1 Products affected

2 Type of change

Product Change Notification					PCN 4797		
owner	creation date	release date	released by	change order no	rev	page	0118.2295
import	2015-12-05	2016-04-08	huberth	2009672	A	1 of 2

Old product appearance	New product appearance

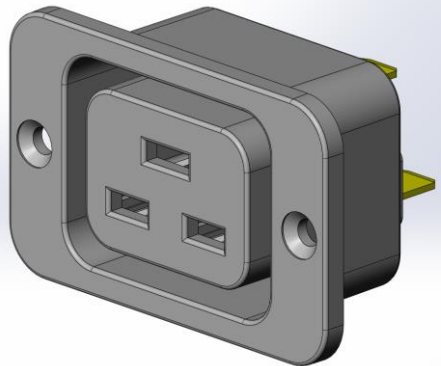
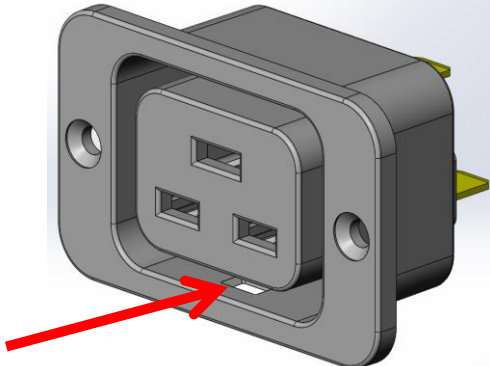
- Standard material changed from PA6 to PA66/6
- V-Lock feature integrated as standard (not an option anymore)

Form	Yes	Socket has notch for V-Lock cord retaining
Fit	No	There are no dimensional changes
Function	Yes	V-Lock feature is standard (not an option anymore)
Production Site	No	There is no change of the production site
Product Label	Yes	There are new order codes
Customer Action	Yes	Consider the new order codes

Old order code	New order code
4797.xxxx.01 4797.xxxx.15	4797.xxxx 4797.xxxx
